## Product Change Notification

**Document No**                      **PCN-A-1060626**                      **Revision**                      **1.0**

**PCN TOPIC:** Winmate replaces FA30-200 motherboard by FA30-210.

**External I/O Layout:**

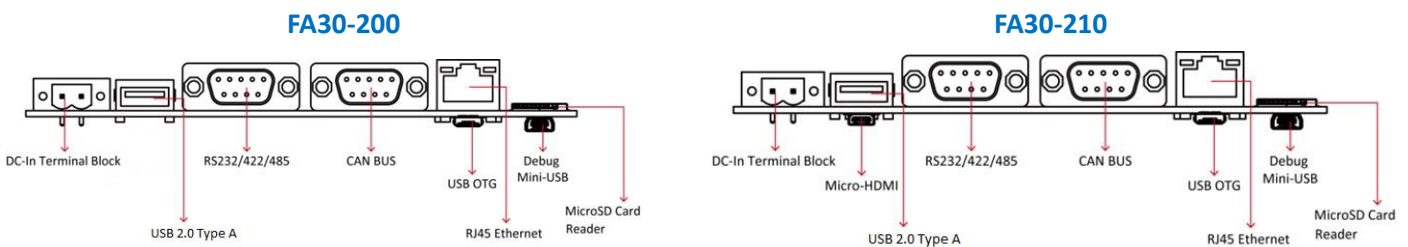
This is the notification for customers that Winmate has already released a new FA30-210 motherboard to replace the FA30-200. Please notice that this change may affect mechanical design of the products that previously have been using the FA30-200 motherboard. New FA30-210 has micro HDMI connector. All the orders from June 19, 2017 will use FA30-210 instead of the FA30-200. Refer to a comparison table below for more details.
